Thursday, June 27, 2019
10:00 am.

SUBDIVISION AUTHORITY AGENDA MEETING NO. 25

RE: Tentative plan of subdivision to create 8 semi-detached residential lots from the NW 36-52-26-W4M, located east of 231 Street NW and south of 97 Avenue NW; **SECORD**

RE: Tentative plan of subdivision to create two (2) additional single detached residential lots from Lot 3, Block 16, Plan 5058 ET located south of 98 Avenue NW and east of 155 Street NW; **WEST JASPER PLACE**

MODEL:
Site Plan
8739 155 Street, Edmonton
Lot: 3 Block: 16 Plan: 5059ET

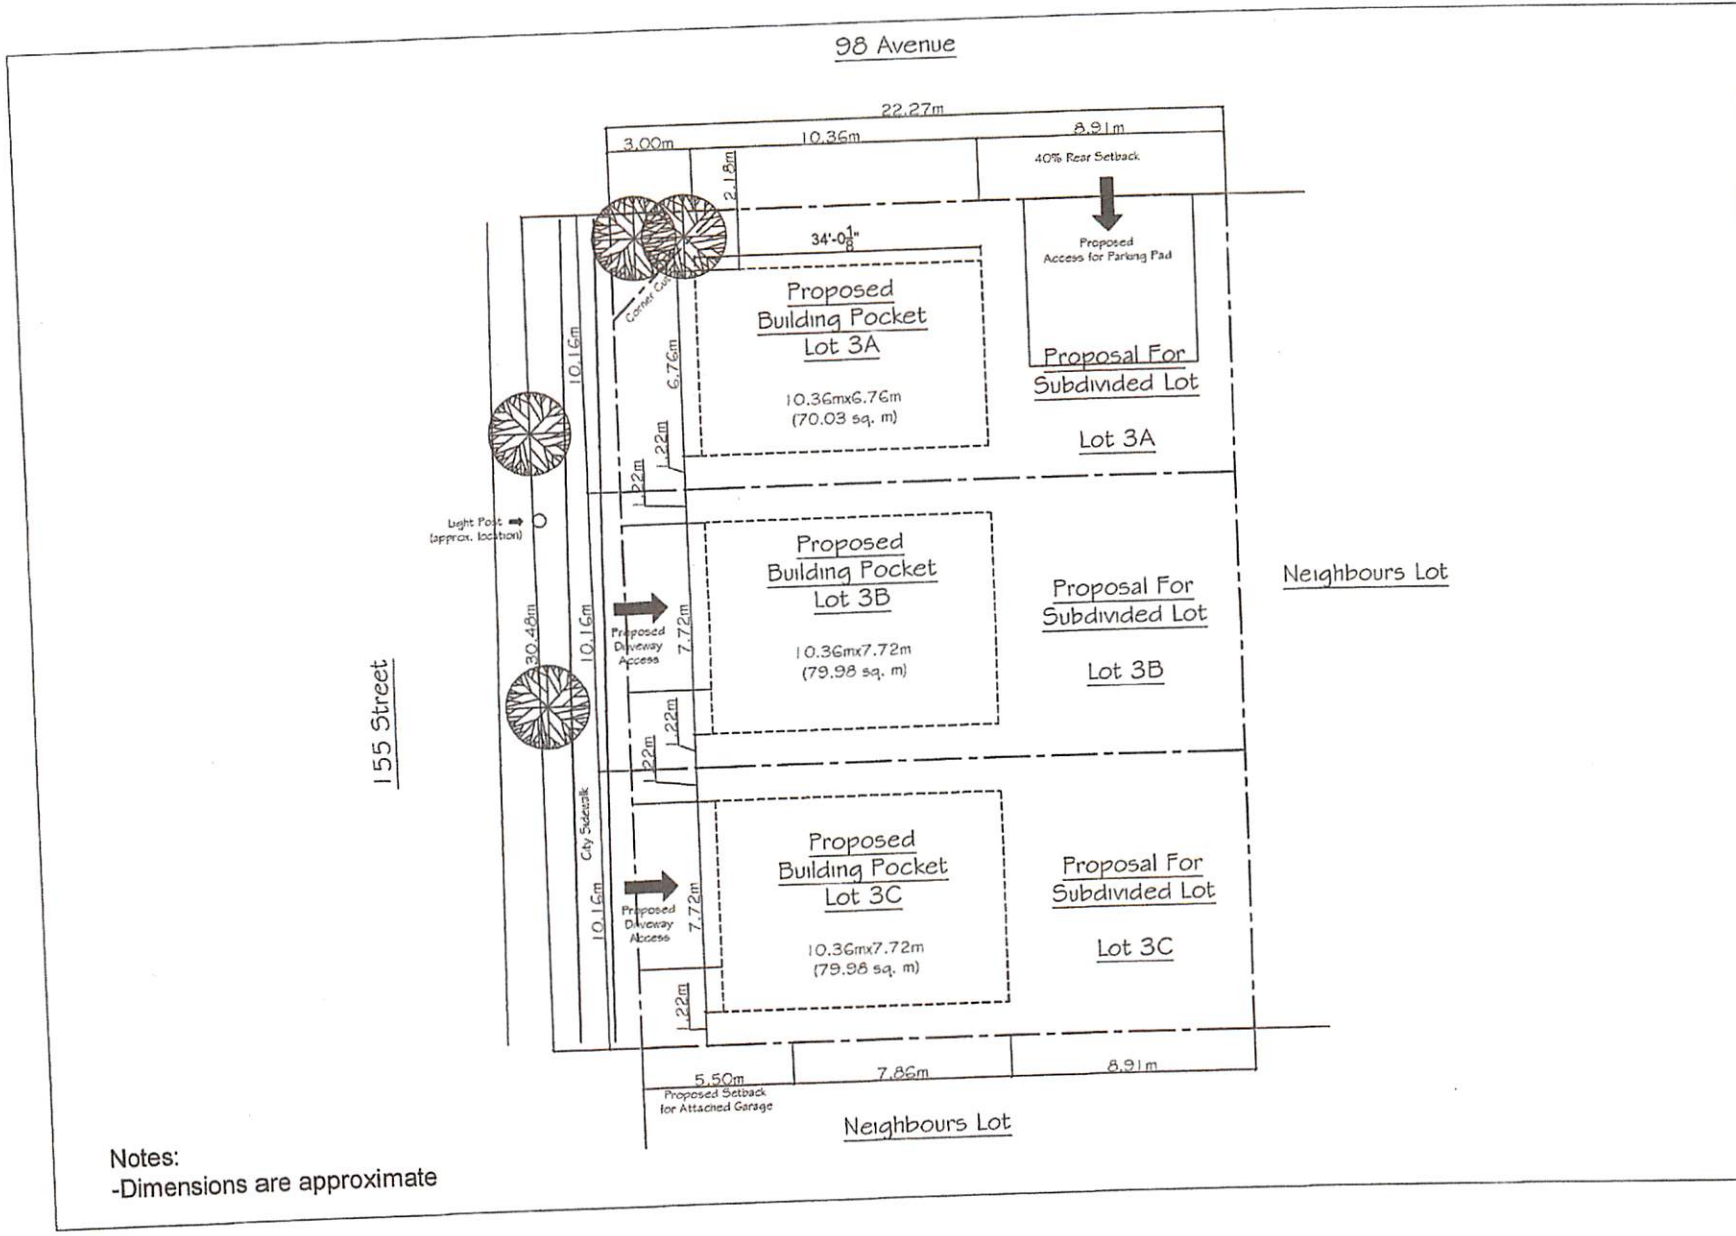
The Subdivision by Plan is REFUSED on June 27, 2019 for the following reasons:

1. The proposed subdivision does not comply with the Development Regulations identified in Section 41.1(3) of the City of Edmonton Zoning Bylaw 12800:

The application proposes to subdivide the subject lot, which is zoned (RF1) Single Detached Residential Zone, into two (2) additional single detached residential lots for a total of three (3) lots. This is one (1) lot more than is allowed in Section 41.1(3) of the City of Edmonton Zoning Bylaw 12800.

The proposal will also result in Site Depths and Site Areas that are uncharacteristically small when compared to adjacent properties. For example, with the exception of the lot immediately east of the subject lot, the depth of the properties on the block face are approximately 45 m. The proposed lot depth for Lots 3A, 3B, and 3C is 22.27 m which is 50.51% less than the lots on the block face.

With the exception of the lot immediately east of the subject lot and two lots southwest of the subject lot, site areas for surrounding properties are approximately 675 square meters. The proposed site area for Lots 3A, 3B and 3C is 226.26 square meters which is 66.48 % less than most of the lots on the block face and 33.84% less than the two smallest lots southwest of the subject lot. Therefore, the proposal is out of character with the existing block face and surrounding properties.

2. The proposed subdivision does not comply with the minimum development regulations identified in Section 110.4(1)(c) of the City of Edmonton Zoning Bylaw 12800. The site is zoned (RF1) Single Detached Residential Zone. The minimum site depth identified in the RF1 Zone for single detached housing is 30.0 metres. The site depth of the proposed lots is 22.27 metres and is therefore deficient by 7.73 metres or 25.76%.
3. The proposed subdivision does not comply with the minimum development regulations identified in Section 110.4(1)(a) of the City of Edmonton Zoning Bylaw 12800. The site is zoned (RF1) Single Detached Residential Zone. The minimum site area identified in the RF1 Zone for

single detached housing is 250.8 square metres. The site area of the proposed lots is 226.26 square metres and is therefore deficient by 24.54 square metres or 9.78%.

4. The proposed subdivision will create three (3) non-conforming lots that do not meet the site depth and site area development regulation in the Edmonton Zoning Bylaw 12800. This situation will create unnecessary hardship for existing and future landowners. Landowners wishing to further develop or redevelop their site will require a Development Permit variance.

5. Given the absence of a lane to provide access to the existing site, access to the proposed lots must be from 155 Street NW or 98 Avenue NW. This would not align with the general intent of the Residential Infill Guidelines, which "should respect the role of lanes not only as a primary vehicular access route but as a factor in maintaining the livability of neighbourhoods" (City of Edmonton Policy C551, General Principle #8). The creation of two (2) additional lots instead of one (1) additional lot exacerbates the situation by requiring two (2) additional front driveways instead of one (1) additional front driveway.

LOT 20A, BLOCK 2, PLAN 2383 N.Y.

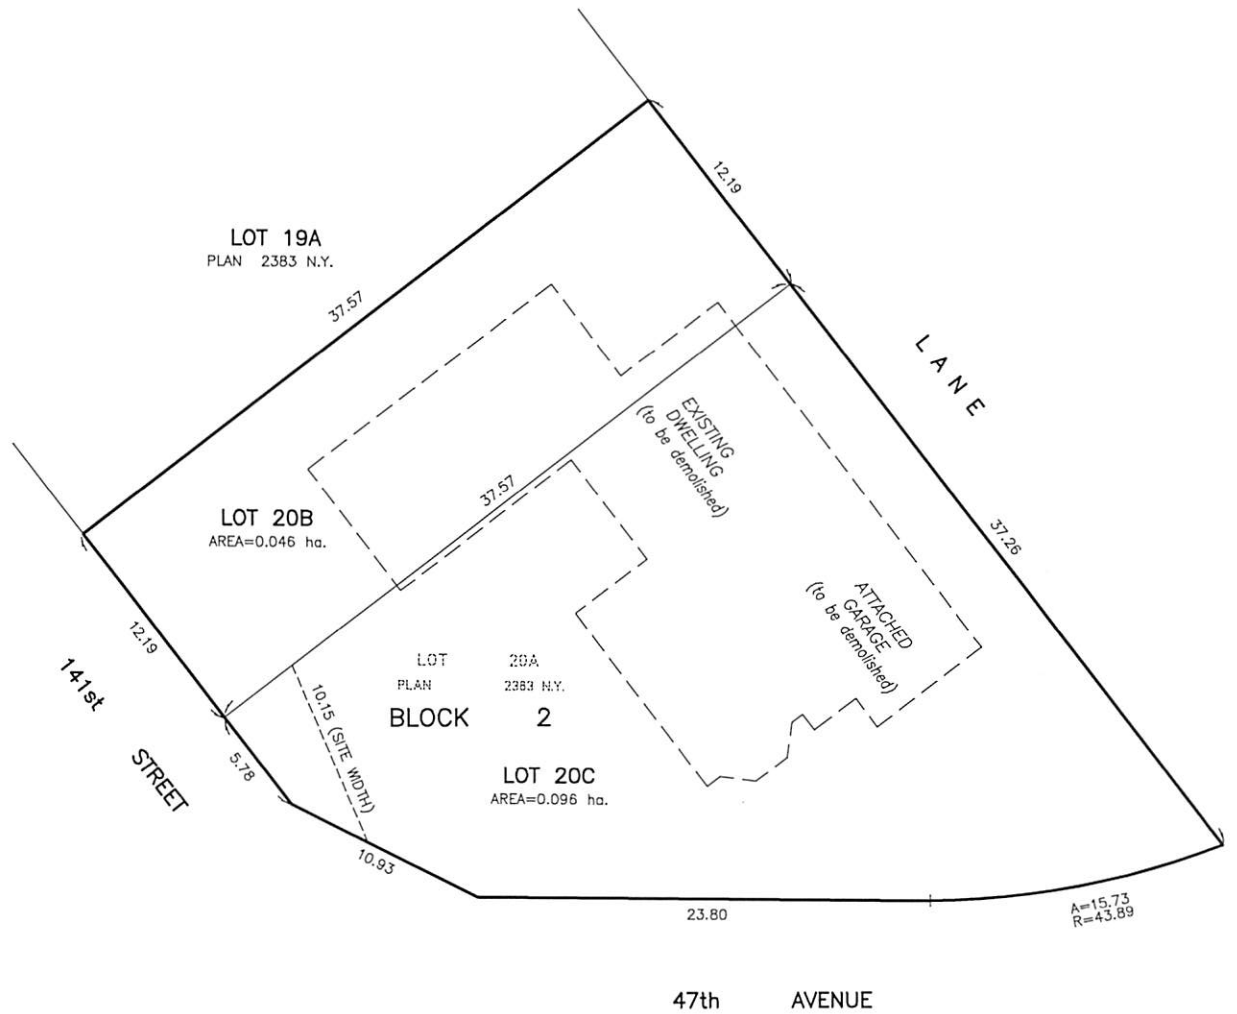
- There are existing boulevard trees adjacent to the site on 141 Street NW and 47 Avenue NW that must be protected during construction. For information about tree protection please refer to the City of Edmonton's website (Trees and Construction).
- Access for future development must be to the adjacent alley in conformance with Mature Neighbourhood Overlay Section 814.3(17) of the Zoning Bylaw #12800.
- There is an existing access to 47 Avenue NW. Upon redevelopment of proposed Lot 20C, the existing residential access to 47 Avenue NW must be removed. The owner/applicant will be required to obtain a Permit to remove the access, available from Development and Zoning Services, 2nd Floor, 10111 - 104 Avenue NW, Edmonton.

- The existing services (water and storm) enter the proposed subdivision approximately 14.9 m south of the north property line of Lot 20A off 141 Street NW. The existing sanitary service enters the proposed subdivision approximately 24.6 m south of the north property line of Lot 20A off the lane. As per the EPCOR Drainage Services Bylaw and the EPCOR Water Services and Wastewater Treatment Bylaw, these services cannot cross the proposed property line.

LOT 7, BLOCK 13, PLAN 8111 E.T.

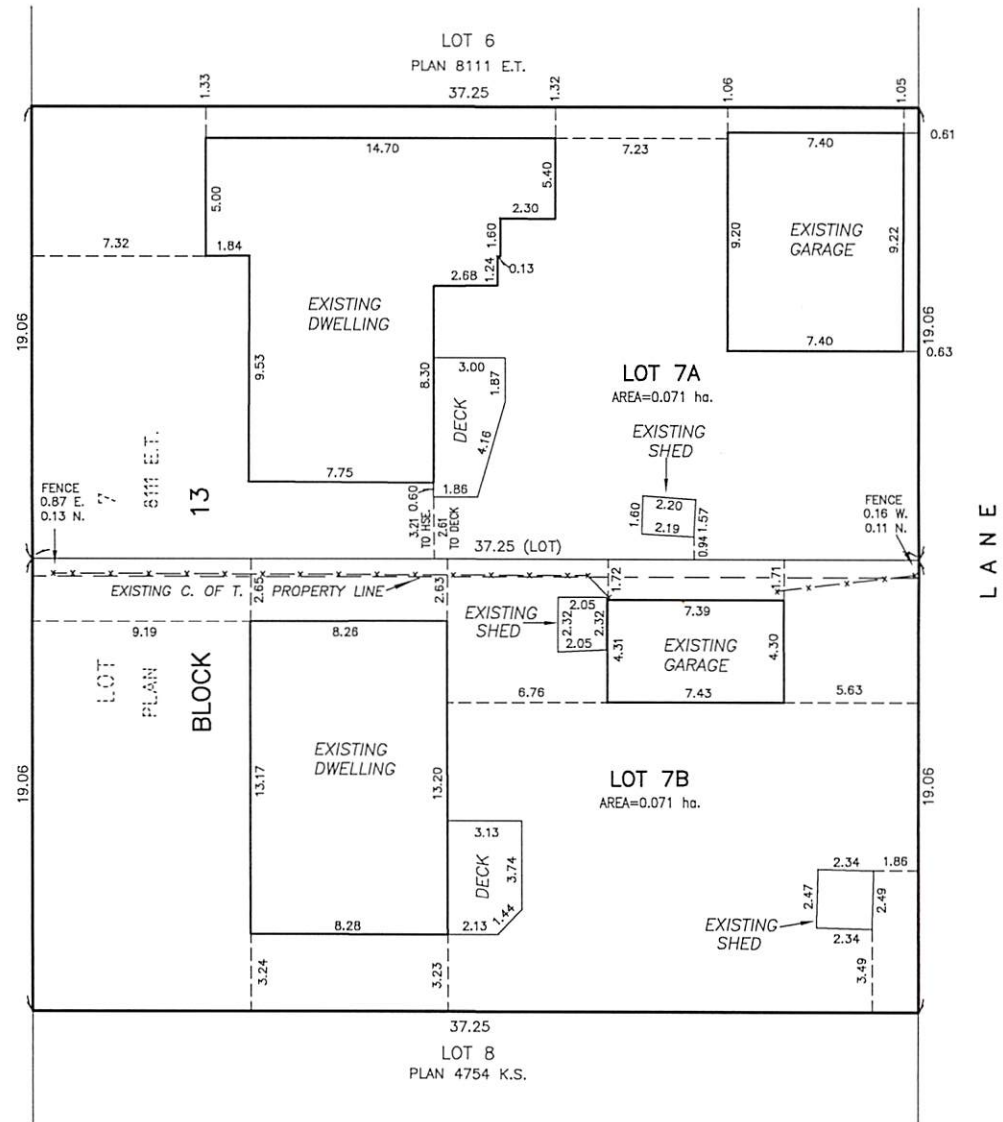
- Access for future development must be to the adjacent alley in conformance with Mature Neighbourhood Overlay Section 814.3(17) of the Zoning Bylaw #12800.

- The existing services (water and sanitary) enter the proposed subdivision approximately 9.6 m south of the northern property line of proposed Lot 7A, and enter approximately 13.1 m north of the southern property line of proposed Lot 7B. As per the EPCOR Drainage Services Bylaw and the EPCOR Water Services and Wastewater Treatment Bylaw, these services cannot cross the proposed property line.

- There is a deficiency in on-street hydrant spacing adjacent to the property. The applicant/owner is advised to review on-site fire protection requirements to ensure adequate coverage (contact EPCOR Water at 780-412-3955).

- Please note however that the existing water service to Lot 7A is a LEAD service. If any construction or development occurs this service cannot be utilized to service the proposed development. Refer to Note 3.0 (see letter online dated June 11, 2019 from Gerald Wildeman, EPCOR Water Services) for further details.

LOT 32, BLOCK 12, PLAN 4116 H.W.

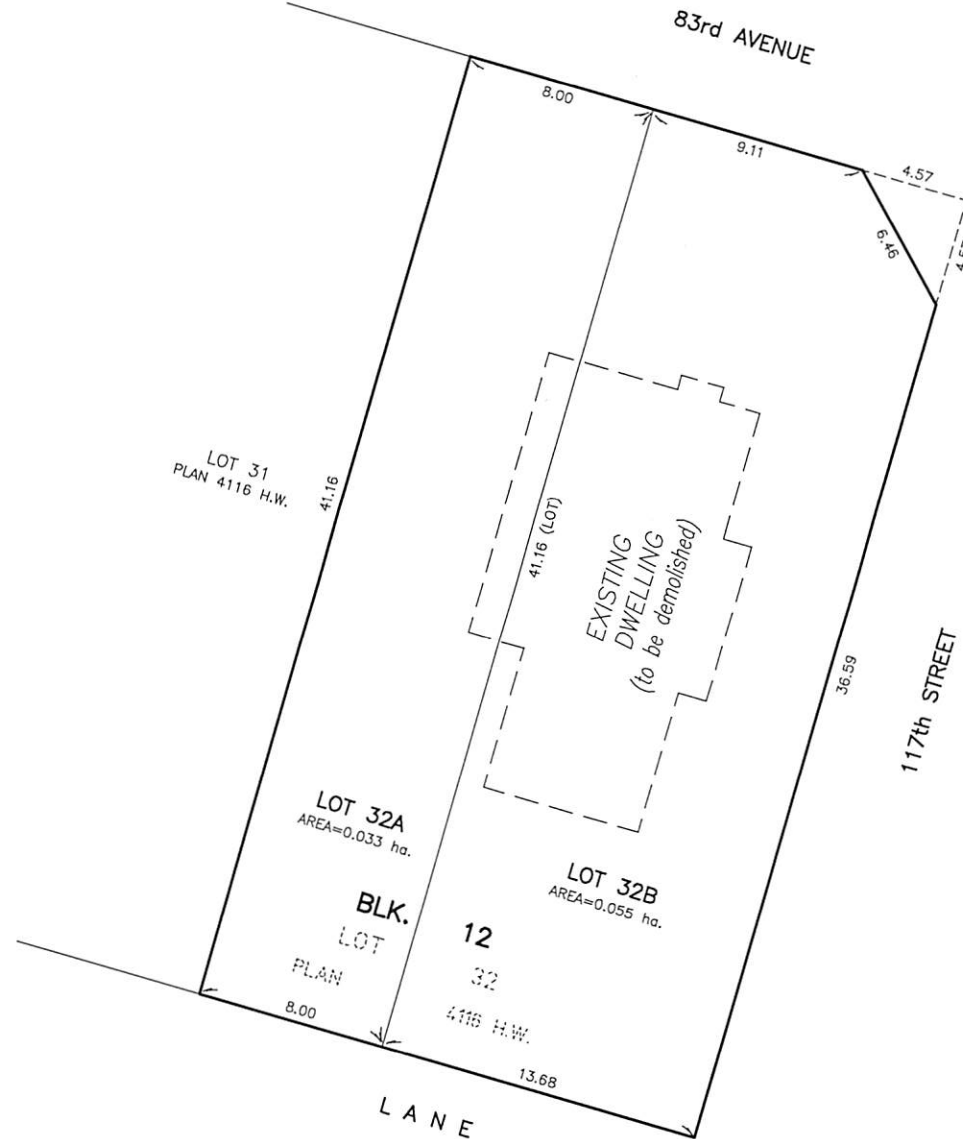
- There are existing boulevard trees adjacent to the site on 83 Avenue NW that must be protected during construction. For information about tree protection please refer to the City of Edmonton's website (Trees and Construction).
- Access for future development must be to the adjacent alley in conformance with Mature Neighbourhood Overlay Section 814.3(17) of the Zoning Bylaw #12800.
- There is an existing access to 117 Street NW. Upon redevelopment of proposed Lot 32B, the existing residential access to 117 Street NW must be removed. The owner/applicant will be required to obtain a Permit to remove the access, available from Development and Zoning Services, 2nd Floor, 10111 - 104 Avenue NW, Edmonton.

- The existing services (water and sanitary) enter the proposed subdivision approximately 14.6 m west of the east property line of Lot 32 off the lane. The existing storm service enters the proposed subdivision approximately 11.1 m west of the east property line of Lot 32 off 83 Avenue NW. As per the EPCOR Drainage Services Bylaw and the EPCOR Water Services and Wastewater Treatment Bylaw, these services cannot cross the proposed property line.

LOT 27, BLOCK 12, PLAN 3307 M.C.

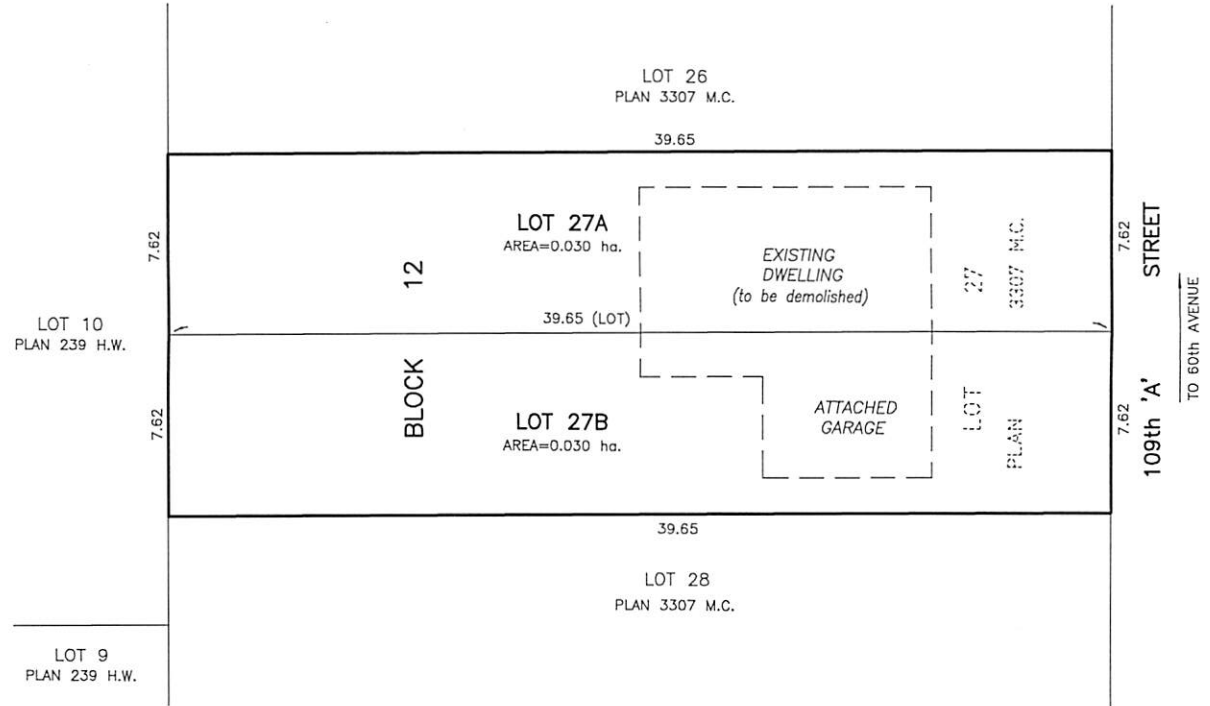
- There is an existing boulevard tree adjacent to the site on 109A Street NW that must be protected during construction. For information about tree protection please refer to the City of Edmonton's website (Trees and Construction).

- The existing services (water and sanitary) enter the proposed subdivision approximately 3.39 m south of the north property line of Lot 27 off 109A Street NW. As per the EPCOR Drainage Services Bylaw and the EPCOR Water Services and Wastewater Treatment Bylaw, these services cannot cross the proposed property line.
